**Concept plan and Stage 1 Project Application
at Shepherds Bay Foreshore, Meadowbank
and Ryde**

MP09_0216 MOD1 and MP09_0219 MOD1

Secretary's Environmental Assessment Report
Section 75W of the
Environmental Planning and Assessment Act 1979

August 2014

Figure 11: Indicative approved foreshore link layout (Source: condition B2 approved plans)

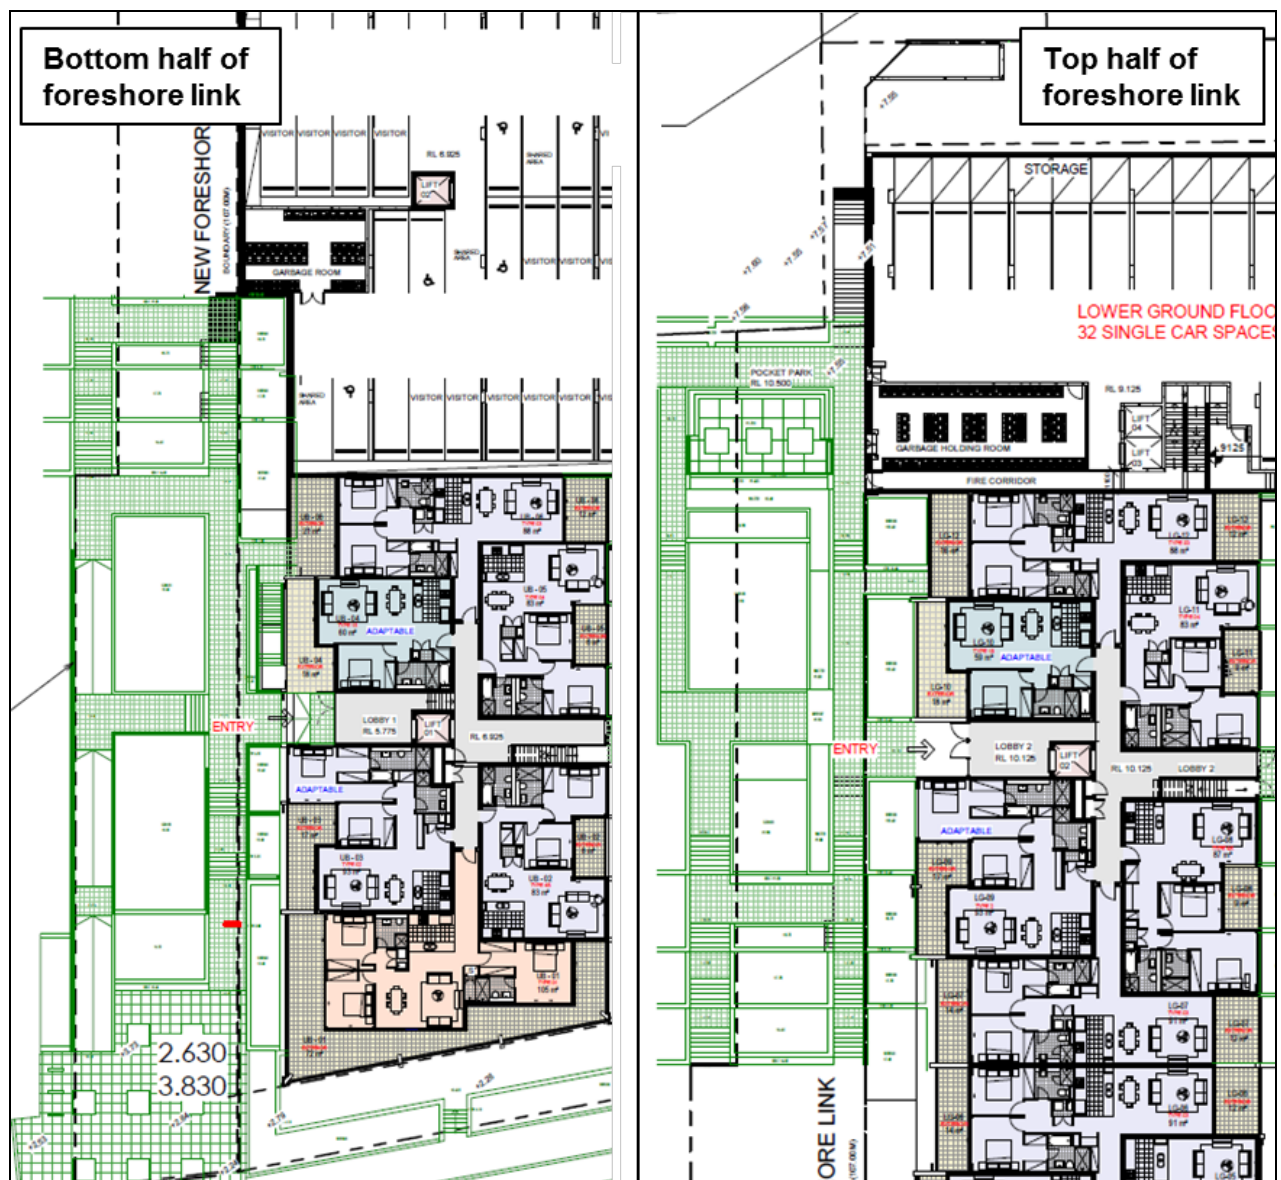
- the Stage 1 development has a stepped building form, which has resulted in the creation of areas of blank walls fronting the public domain (refer to **Figure 13**);
- the foreshore link is uneven and consists of a relatively complex/challenging series of steps and platforms; and
- the foreshore link is provided in addition to the two north/south routes required by FEAR 15 to demonstrate accessible paths of travel through the site.

Council has objected to the revised foreshore link design, stating that:

- the total drop from the Nancarrow Avenue road extension to the regraded foreshore link would be 9 metres. The resulting staircase which addresses this level change is significant in length, comprises many switch-backs, does not allow for sufficient respite/resting places and would inhibit pedestrian movement;
- the introduction of stairs at the northern end of the foreshore link results in amenity issues (residential amenity is discussed at **Section 5.4.1**);
- the provision of large planters between lower level apartments and the foreshore link inappropriately separates the apartments from the foreshore link; and
- the foreshore link should be delivered at Stage 1 (not Stage 2) as delayed delivery would result in insufficient open space provision for Stage 1.

The department notes that the proposed regraded foreshore link would allow for the provision of six large areas of flat open space. When compared to the approved foreshore link, the proposal has provided an increase in functional/usable open space and an overall reduction of hard-paved circulation areas and staircases (refer to **Figures 11 and 12**). The department considers that these changes represent significant improvements to the overall design, appearance and usability of the public domain.

Figure 12: Proposed landscape masterplan including foreshore link (Base source: proponent's RtS)

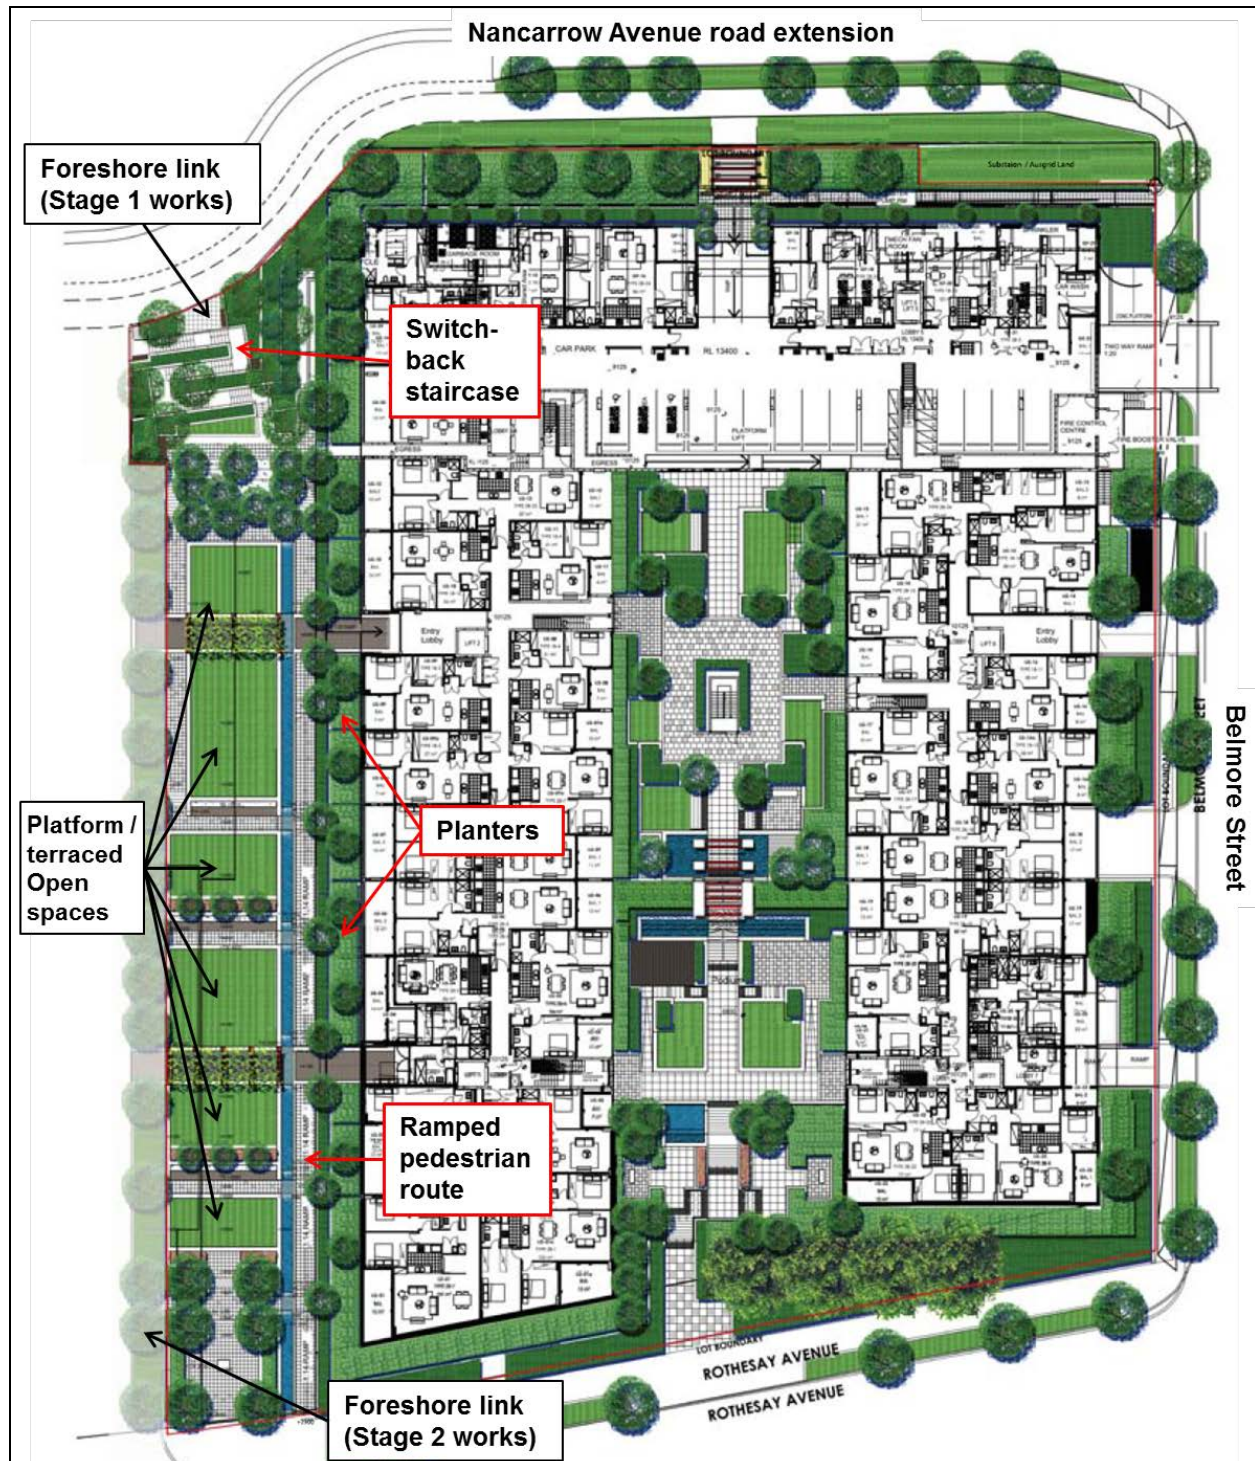
The proposal seeks to revise the foreshore link design to provide a more gentle, and manageable grade for the majority of its length and then address the overall level of change (between Nancarrow Avenue road extension and the foreshore) through the provision of a substantial staircase at its northern end (refer to **Figures 10 and 12**).

With regard to the proposed staircase at the northern end of the foreshore link, the department notes that the proposal has been amended to reduce the originally proposed number of switch-backs from five to two and seating areas and landings have also been provided. The department also notes that the terraced nature of the staircase has allowed for the provision of integrated planting, which softens the appearance of the staircase and is expected to provide a green termination of the foreshore link when viewed along its length. Although the department acknowledges that the proposed staircase is significant in size, it considers it to be acceptable given the design improvements and resulting landscaping.

The department notes that large planters are proposed between the proposed apartments and the foreshore link (refer to **Figure 12**). The department considers this to be acceptable as:

- the planters would allow for the provision of soil depths up to one metre and therefore the establishment of substantial planting (refer to **Figure 22**);
- the provision of a landscaped frontage as a buffer between dwellings and the public domain / street is a standard urban design response. Landscaped buffers are provided to all other street frontages, being Rothesay Avenue, Belmore Street and Nancarrow Avenue road extension elevations;
- the provision of a landscaped buffer would improve the privacy of the proposed apartments; and
- the future landscape planting scheme (condition B3) can be chosen to ensure that the apartments provide a suitable level of passive surveillance.

Figure 13: Approved Belmore Street elevation (top) and foreshore link elevation (bottom). Blank walls and service areas outlined in red (Source: proponent's application)

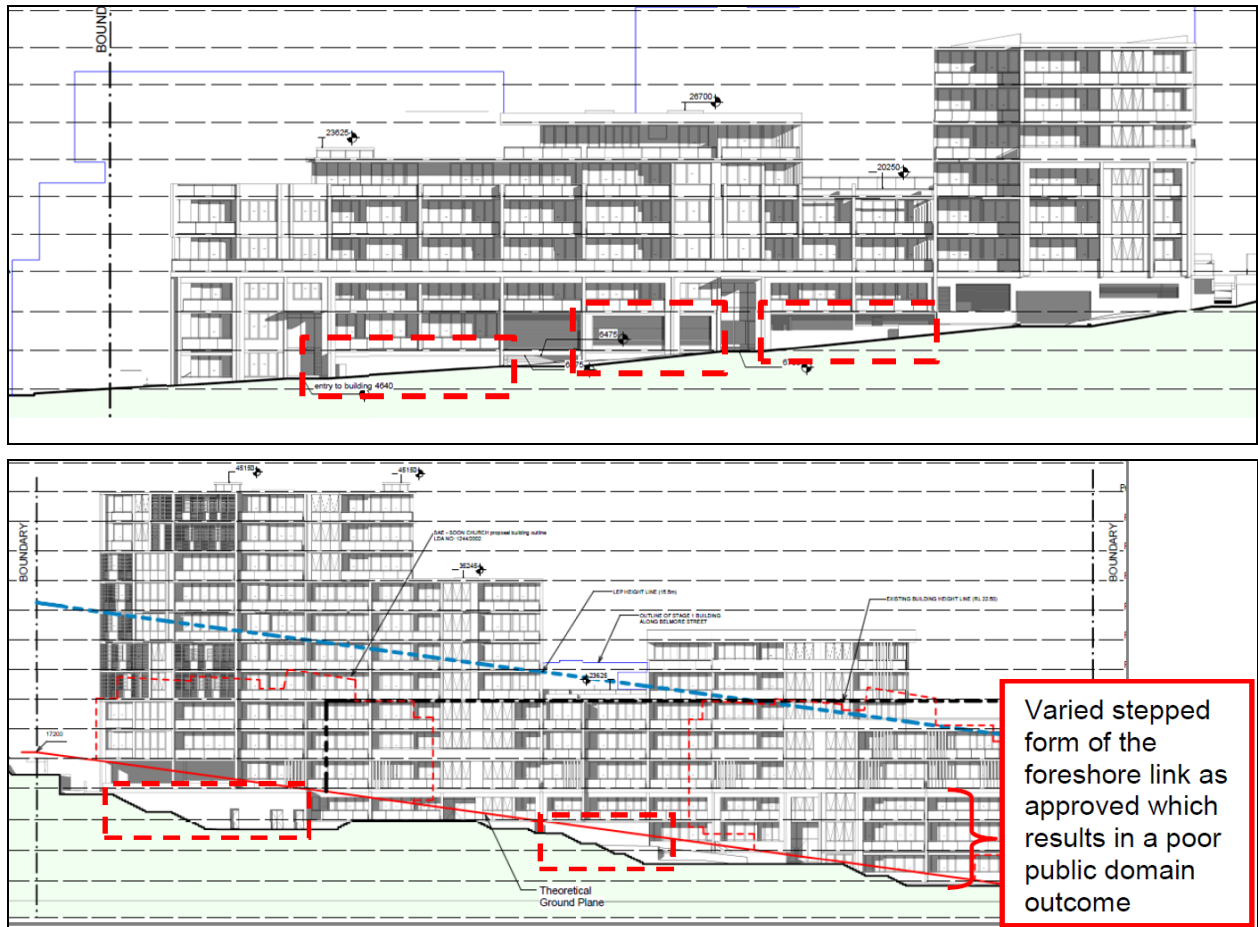
The proponent has noted that despite the building being stepped in response to the fall of the land, the approved elevations include elements of blank elevations fronting the foreshore link and Belmore Street. This is a result of the steeply sloping topography of the site. The proponent argues that the insertion of apartments in these locations would result in an overall improvement by reducing the extent of blank walls (refer to **Figure 13**). To facilitate the proposed changes, the proposal includes amendments to the Building Storey Plan.

- there are alternative design solutions to inserting apartments that could address the existence of blank walls;
- the resulting design of the lower level of the western elevation of the Stage 1 building inadequately activates the foreshore link (refer to **Figure 14**); and
- the new apartments have poor amenity standards.

The department supports the re-grading of the foreshore link due to the benefits discussed in this **Section 5.3**. However, the department notes that if that modification is considered in isolation the ground level relative to the approved western elevation of the Stage 1 building would be lowered and therefore would become disconnected from the building (refer to **Figure 15**). The department therefore considers it necessary to consider revisions to the western elevation of the Stage 1 building in the context of the re-graded foreshore link.

Figure 15: Comparison of ground level and storey heights between the approved and proposed scenarios (Source: proponent's RtS)

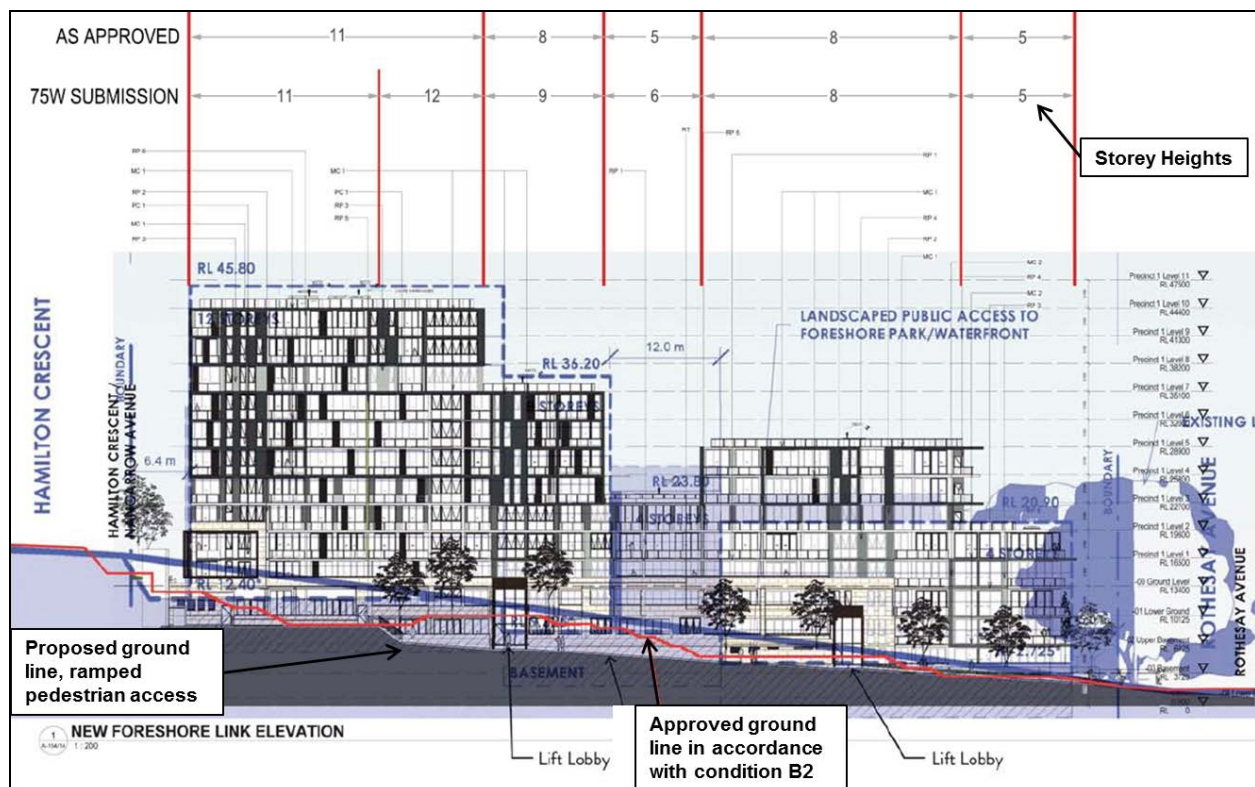
When compared to the currently approved buildings the insertion of new apartments would result in a single storey at the northern end of the Stage 1 foreshore link elevation, as shown at **Figure 15**. However, the modification would not result in an increase above the approved RL height. The department considers that in the context of the scale of the approved development, a localised increase in height of the Stage 1 building by one storey would not have an adverse visual impact.

Figure 16: Provision of dedicated access from the foreshore link and location of relocated staircase (Base source: proponent's RtS)

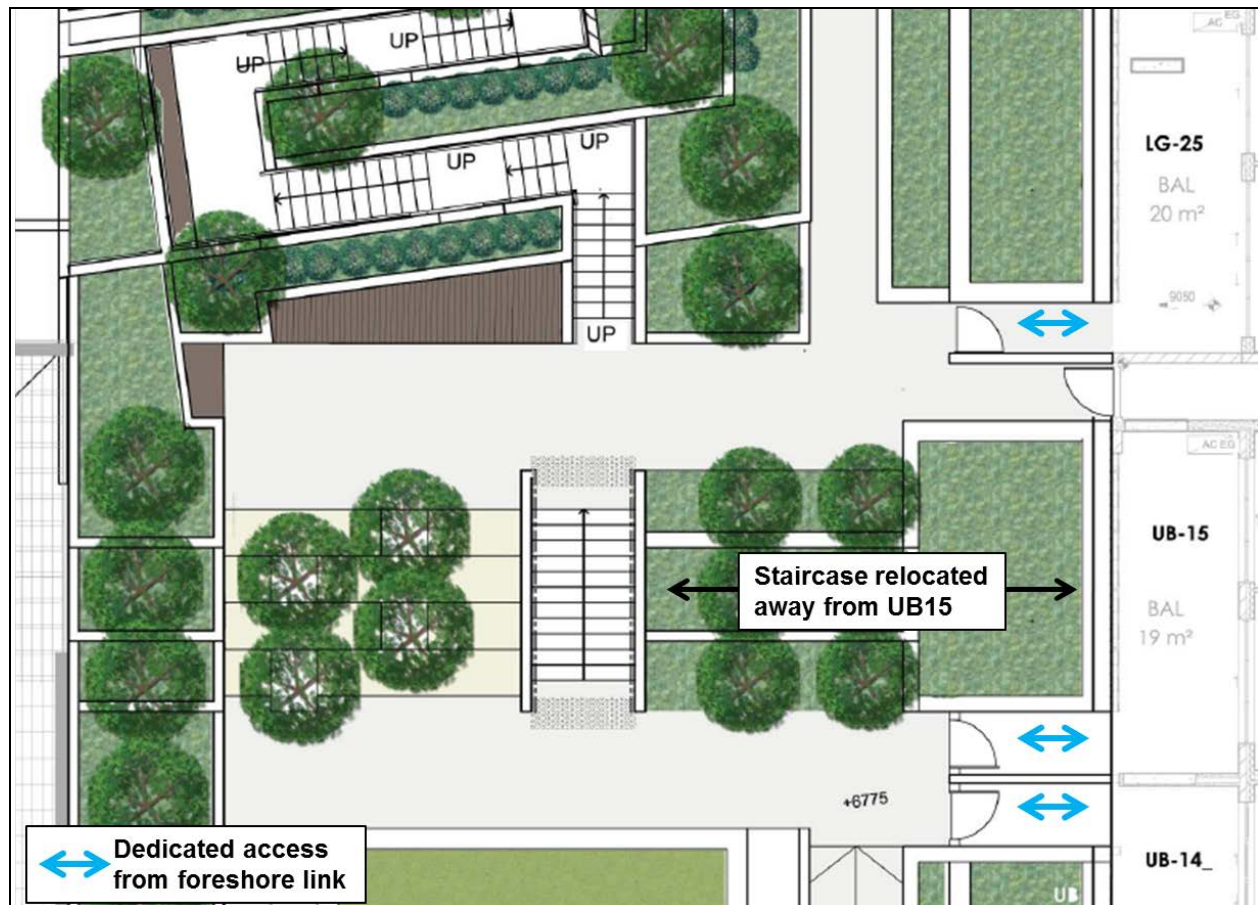
- a sufficient buffer has been provided to ensure that the apartments are not overlooked. Furthermore, in response to Council's concerns the department notes that the foreshore link has been amended to relocate a minor staircase further away from apartment UB15 to improve its amenity (refer to **Figure 16**);

- the apartments have an acceptable internal layout and secure access is provided via communal entrances. Apartments UB14 and UB15 also benefit from direct access from the foreshore link (refer to **Figure 16**).

Figure 17: Access to apartments LG24 and LG25 and location of apartment LG24 within the alcove
(Base source: proponent's RtS)

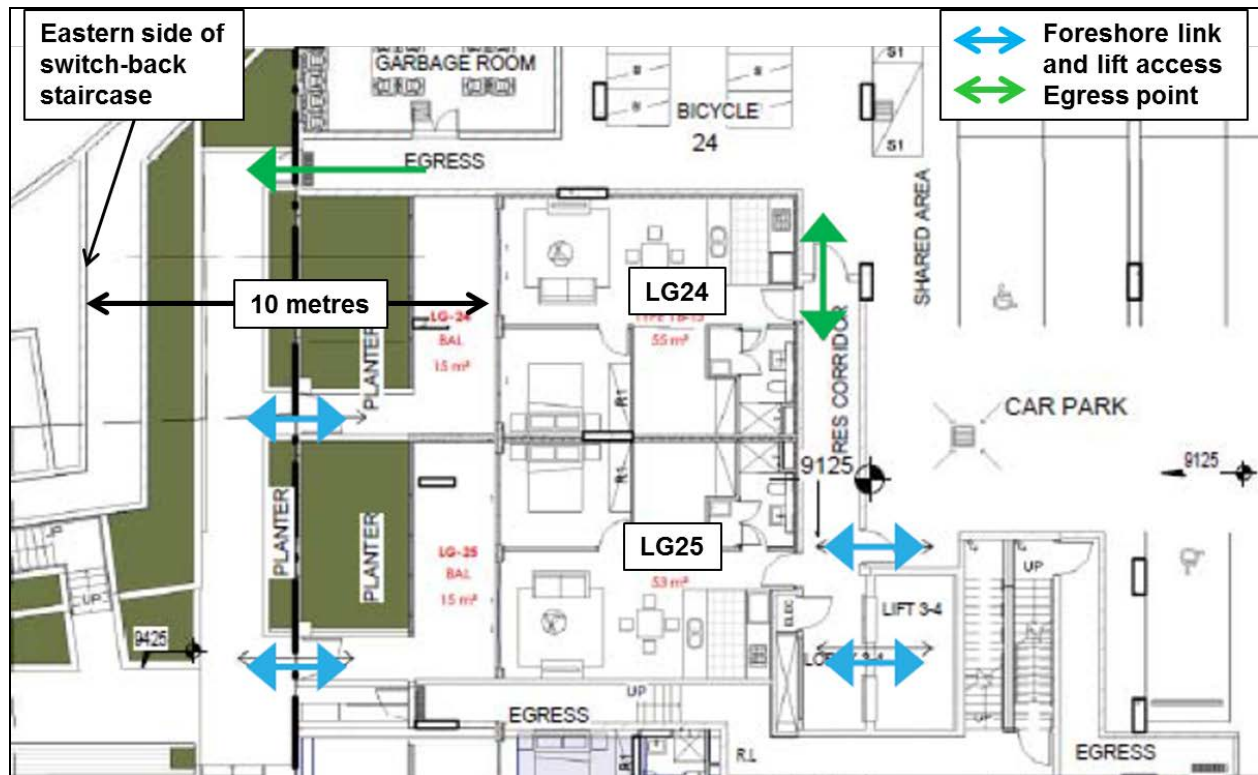
- the apartments have an acceptable internal layout and both are provided with acceptable and secure access comprising: dedicated access from the foreshore link, internal lift access from communal circulation areas and corridor access from the car parking level (refer to **Figure 17**);

- a sufficient buffer has been provided to ensure that the apartments are not overlooked. Furthermore, in response to Council's concerns the department notes that the final element of the switch-back staircase has been relocated further away from apartment LG25;

- as apartment LG24 is located at the northern most end of the foreshore link and faces into a 10 metre wide alcove on to the eastern side of the nine metre high switch-back staircase, its outlook would be severely limited (refer to **Figure 17**). The department does not consider that the proposed increase in floor to ceiling height or landscaping of the eastern side of the switch-back staircase is sufficient to outweigh the negative impact of the combined limited outlook and solar access, nor can this be easily amended to provide for additional internal amenity. The department therefore recommends this apartment be deleted from the scheme.

Figure 18: PPR apartments GF14 and GF15 deleted (top) and proposed apartments GF14 and GF15 (bottom) with sections (Base source: PPR MP09_0219 and proponent's EA)

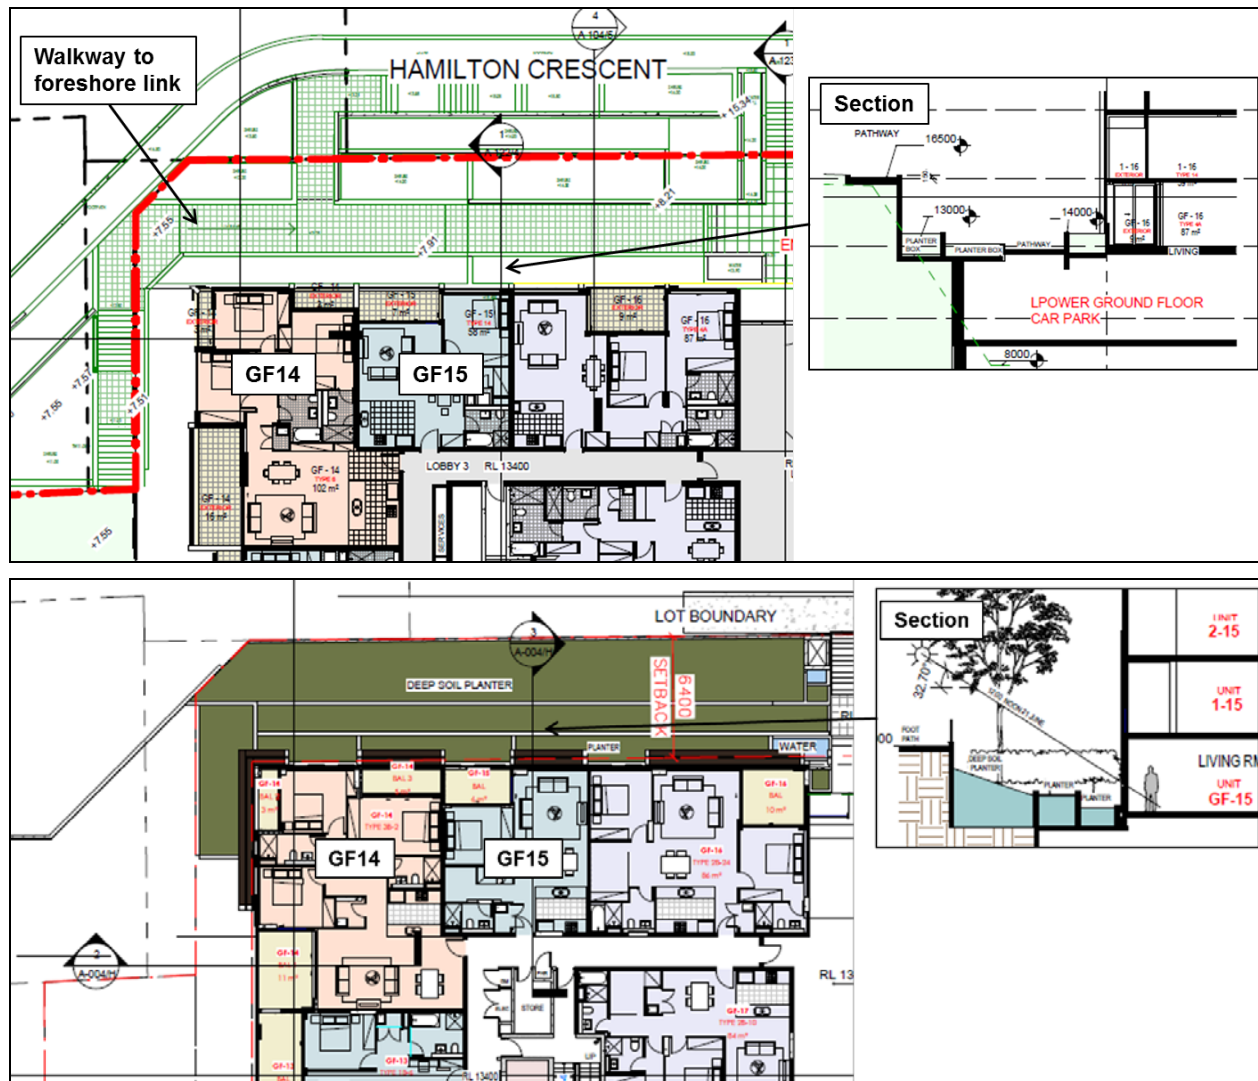
The department notes that the outlook from the deleted apartments would have been towards the blank retaining wall of the Nancarrow Avenue road extension and across a public pathway containing only minor elements of landscaping (refer to **Figure 18**).

- the design of the Nancarrow Avenue setback area (6.4 metres) has been revised and the proposed apartments would be afforded a pleasant outlook to private and terraced landscaping (including enlarged/improved deep soil areas) (refer to **Figure 18**); and
- any casual overlooking from future pedestrians of the Nancarrow Avenue road extension would be mitigated by a landscaped buffer.
